ENGINEERING CHANGE NOTICE # 3

SHEET # 1
MARCH 1966

ENGINEERING CHANGE NOTICE #3

DWG 1-10.001 - MAIN SPAR - WING

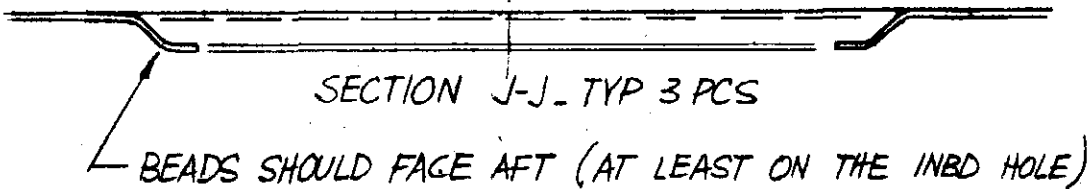
CHANGE TO AVOID INTERFERENCE WITH AILERON CONTROL BELLCRANK

DWG 1-20.003 - STABILATOR - EMPENAGE
LENGTH OF ALUMINUM PLUG WAS 1.00
SHOULD BE 1.25

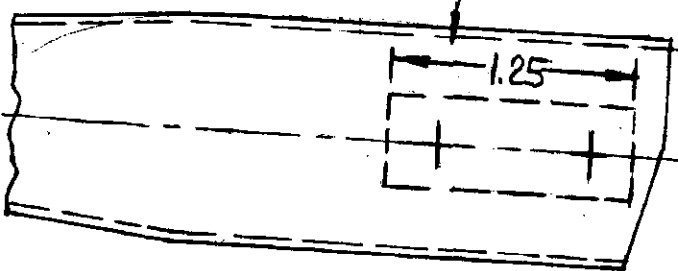
C-C
(CORRECT ERROR)

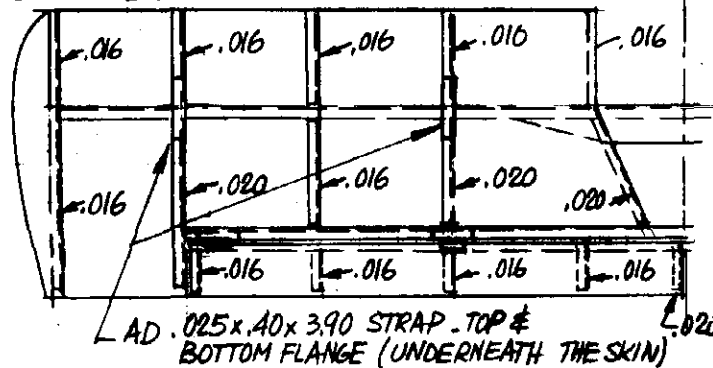
RIB THICKNESS - IF YOU DID NOT BUILT YOUR STABILATOR YET. CORRECT YOUR DRAWING AS SHOWN.
IF YOU BUILT THE STABILATOR ALLREADY LEAVE IT AS 'S. NOTICE THAT WITH NEW THICKNESSES. ALL RIBS HAVE LIGHTENING HOLES.
